Japan Positions on
Battery Durability GTR
@EVE51

8 & 9 July. 2021

Japan Positions on Open Issues

Japan Proposal on Part A and Part B process

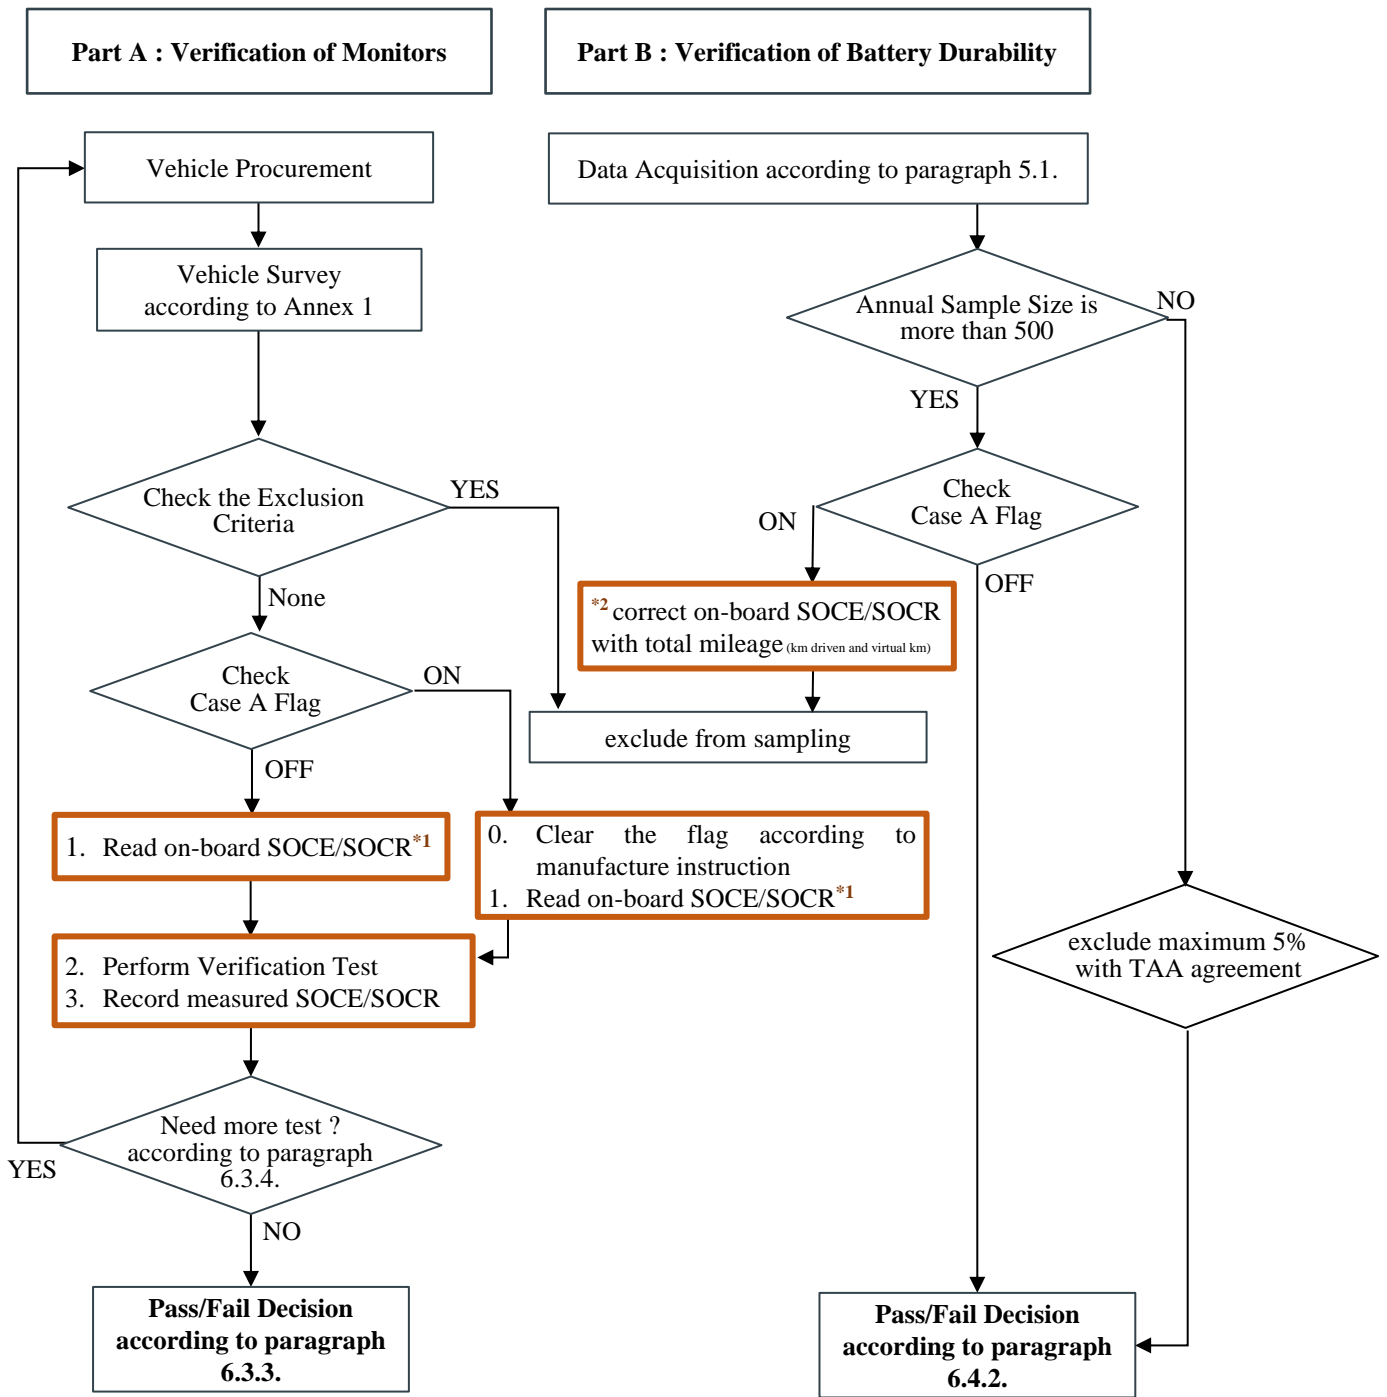
*1 : on-board SOCE/SOCR before verification test shall be used for $SOC_{read,i}$ (Part A verification) considering the consistency between Part A and Part B

*2 : the additional information (on-board SOCE/SOCR and total mileage) is a kind of “deterrent effect” to prevent the misuse from going into the market
